FINAL
DRAINAGE PLAN AND REPORT

**8140 and 8150
CESSNA DRIVE**

**PROPOSED AIRPORT HANGER
LOT 7 BLOCK 1
MEADOW LAKE AIRPORT
FILING NO. 2**

Drainage Report - Final_V2_Comments.pdf Markup Summary

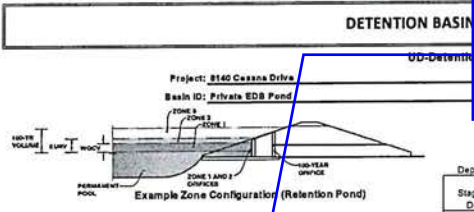
Please include calculations to include the future hangars impervious areas since pond will have to be retrofitted in the future in another site development plan.

DETENTION BASIN STAGE-STORAGE TABLE BUILDER

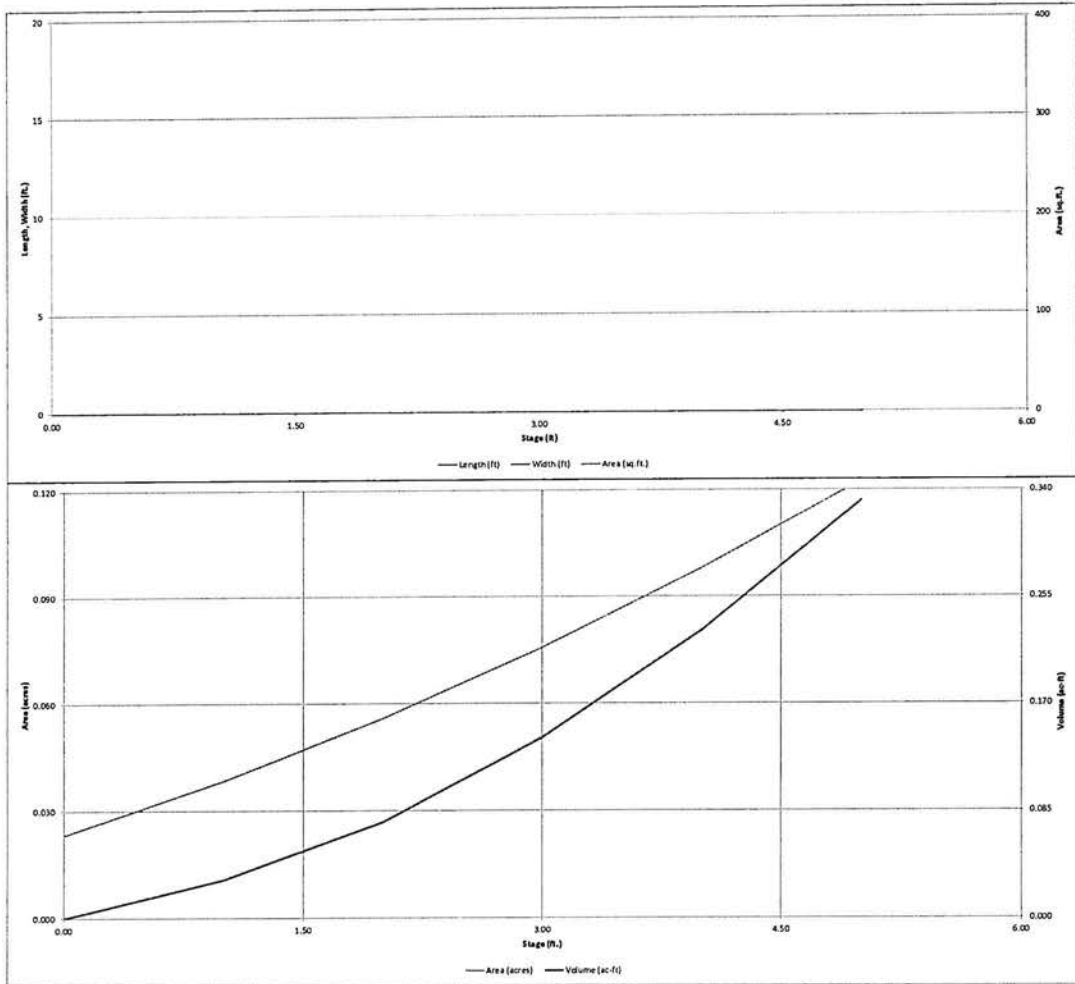
Please include impervious amounts for future hangars that are shown in the site development plan, it appears that it is more than 50%.

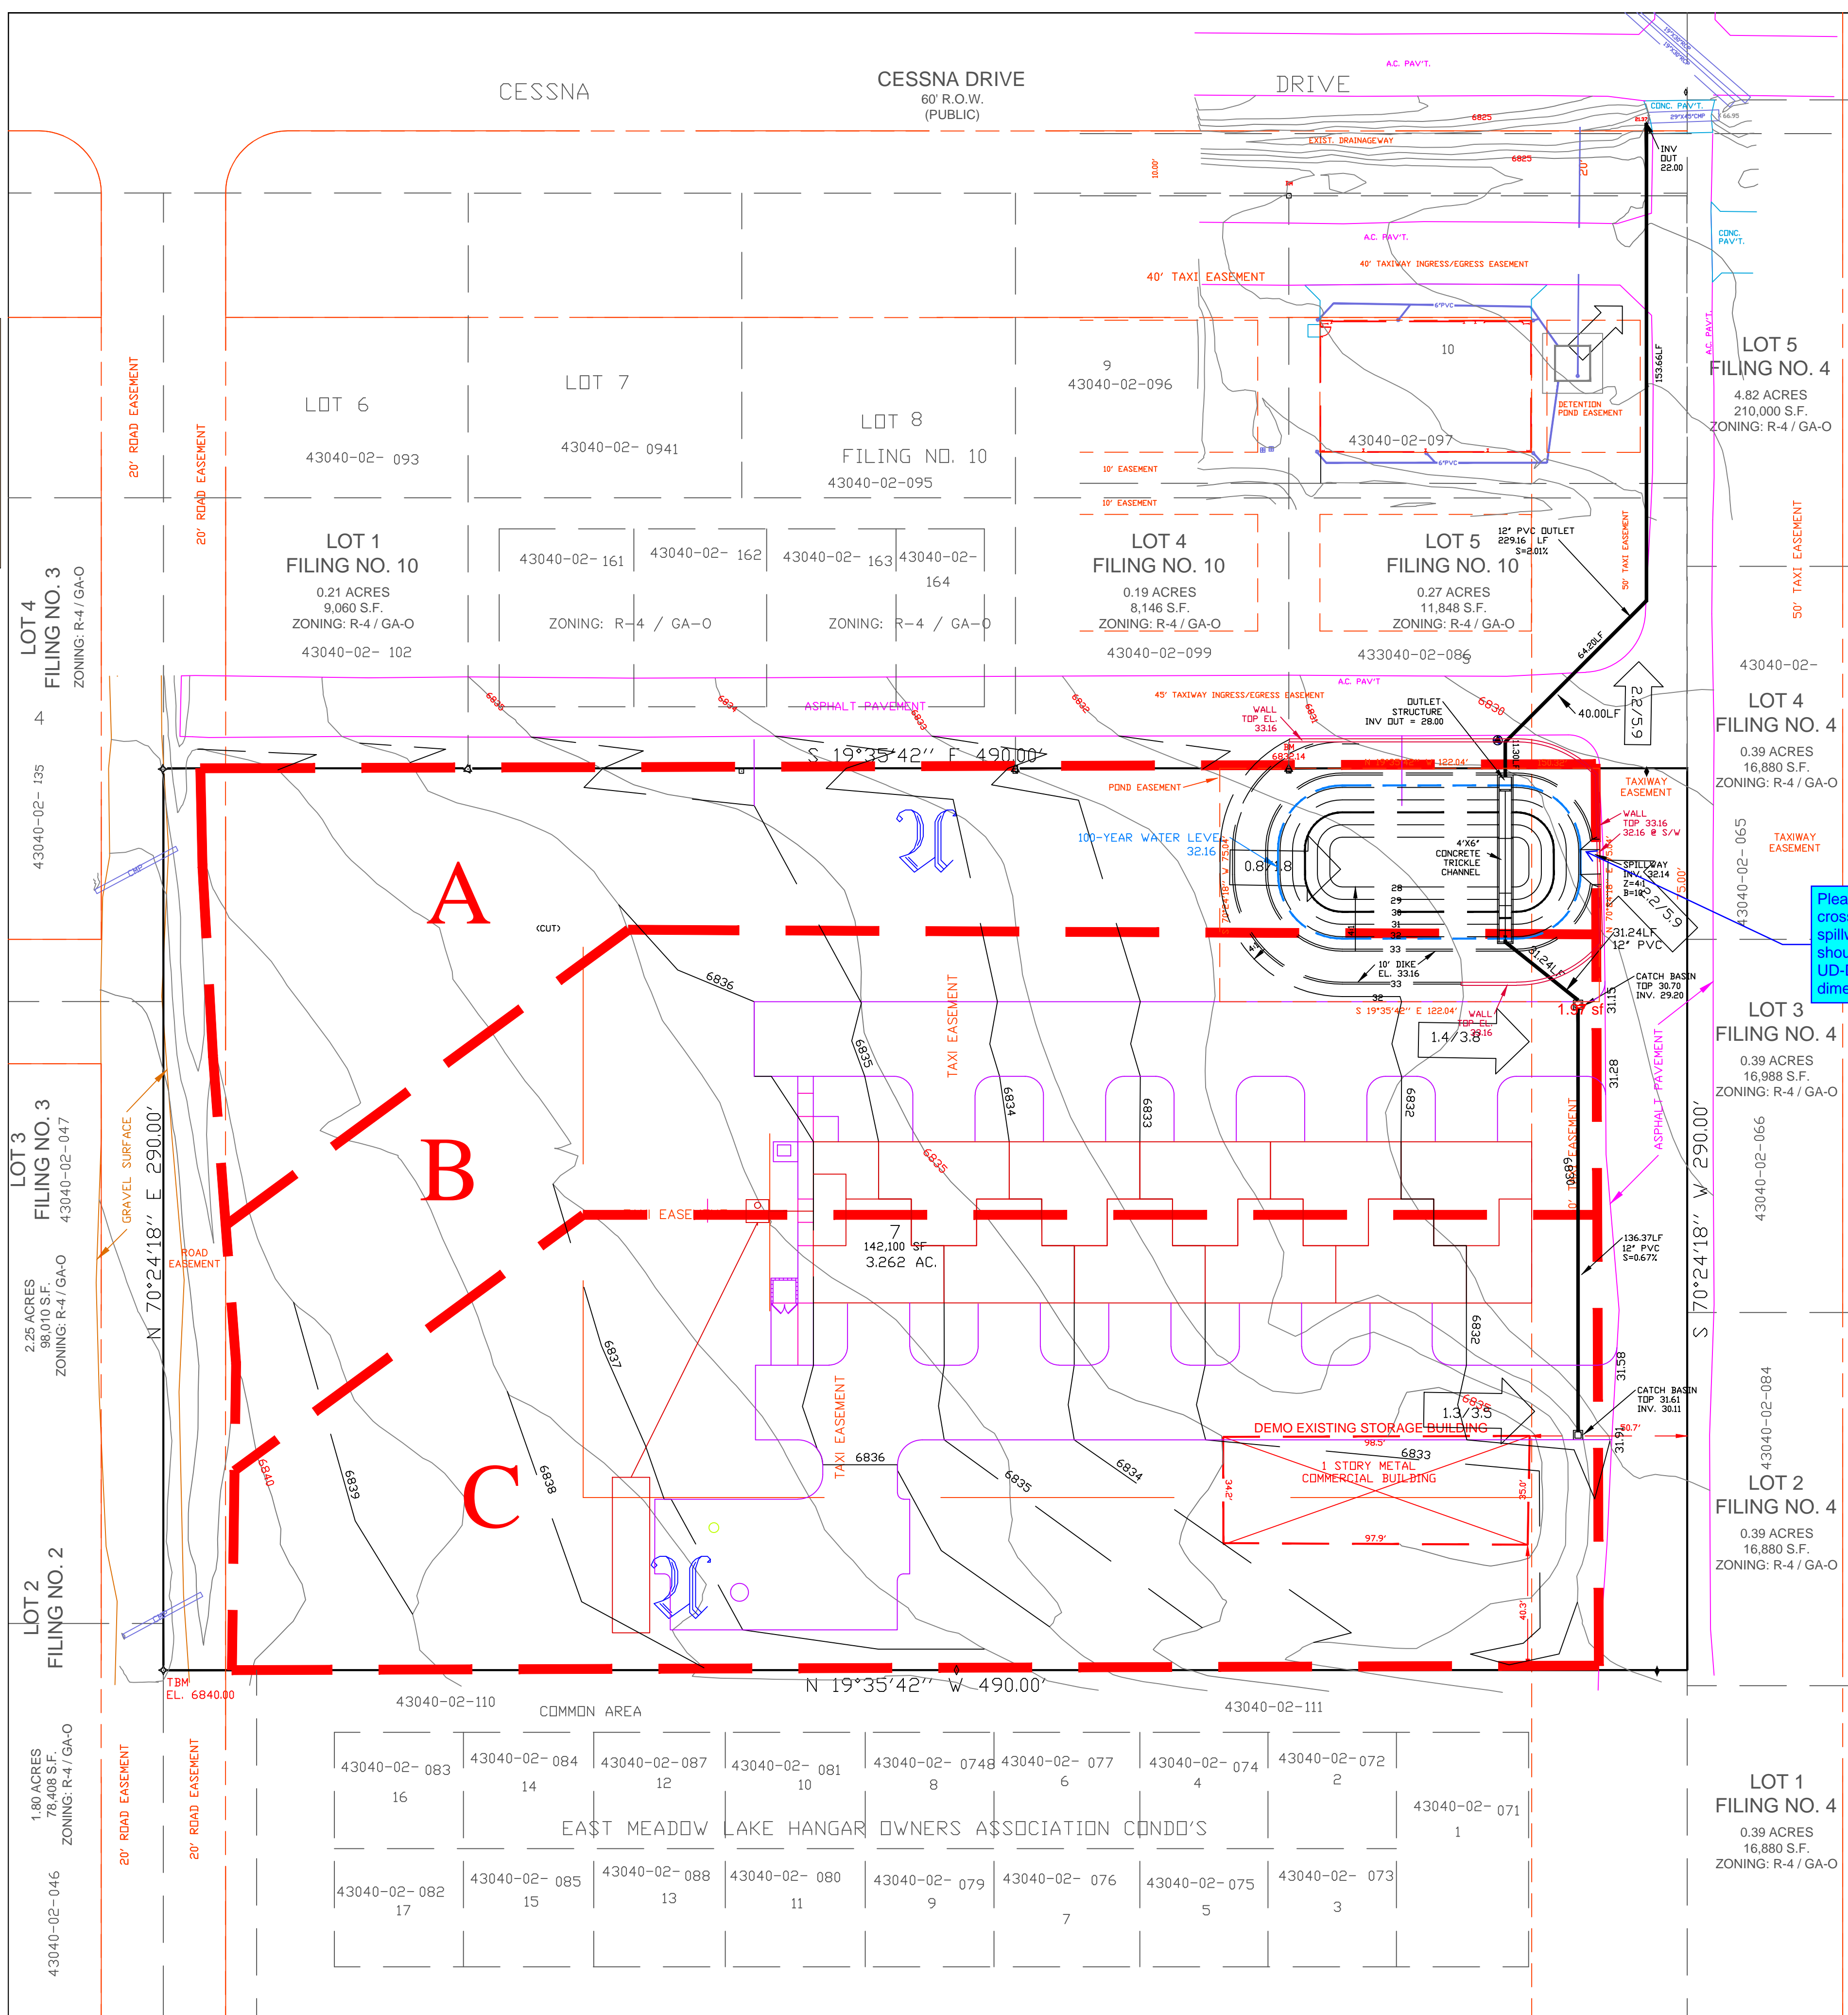
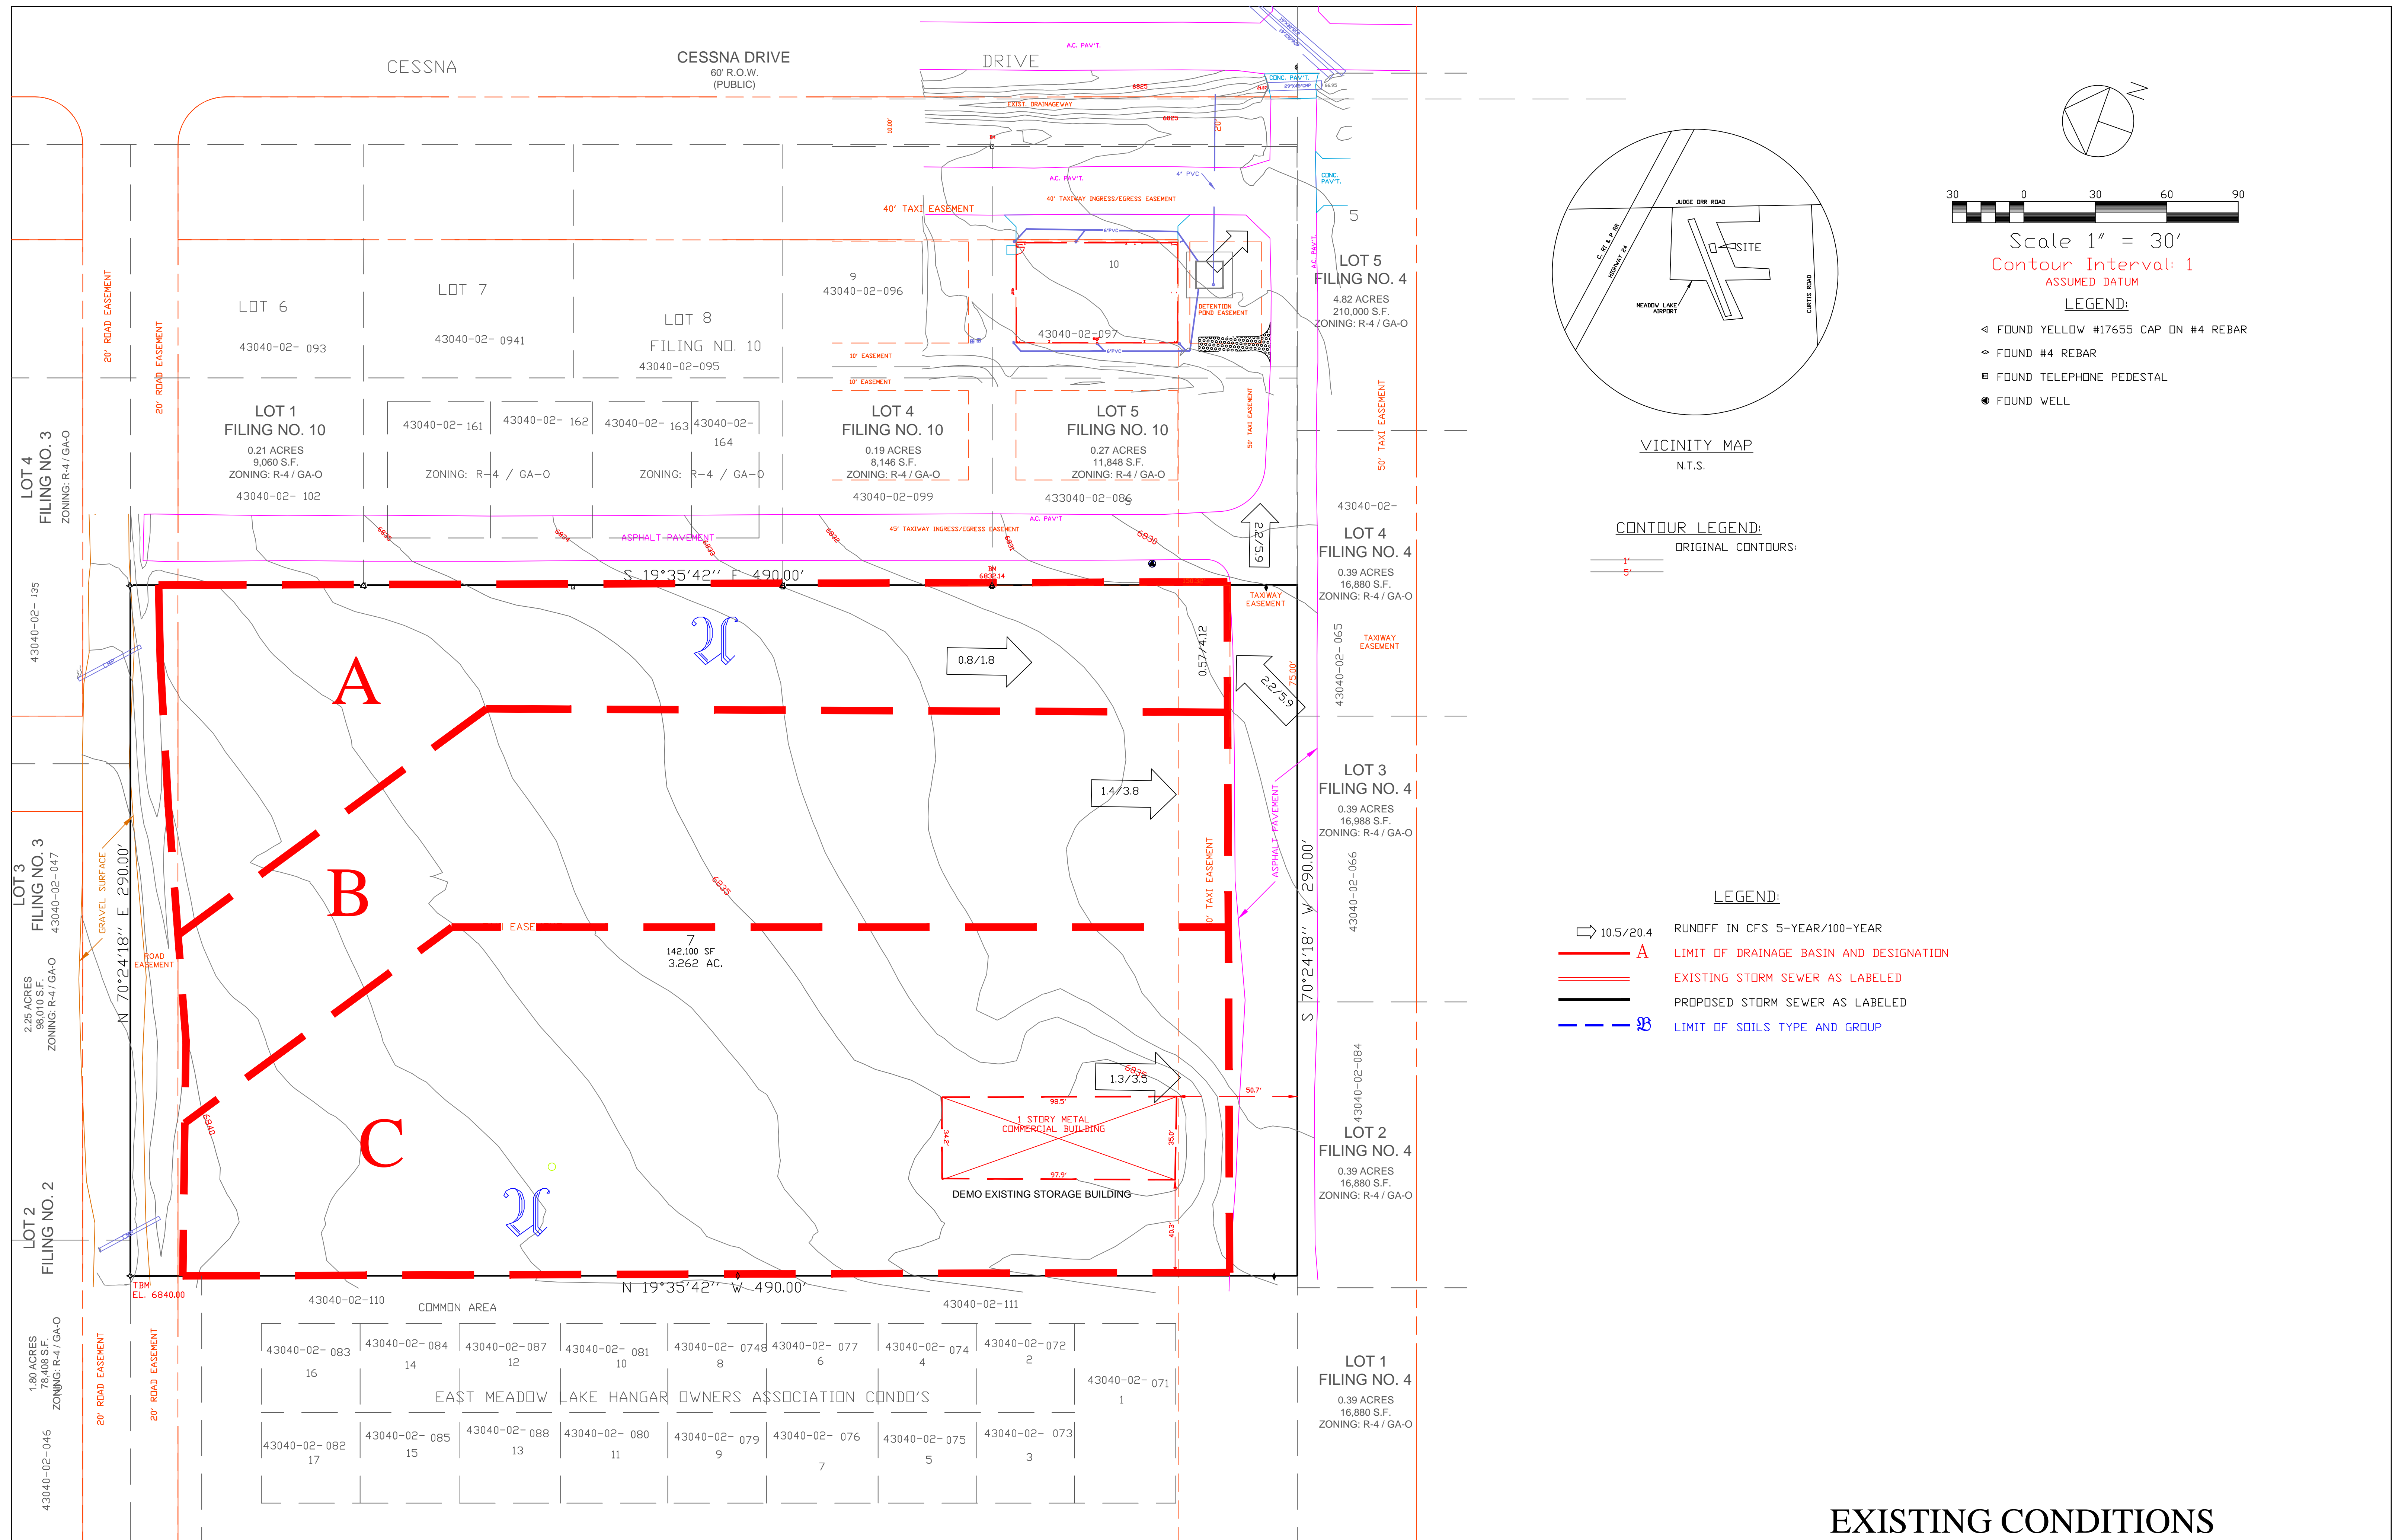
provide calcs for existing drainage ditch capacities and proposed flows

Please provide a cross section of the spillway. Dimensions should match UD-Detention input dimensions.
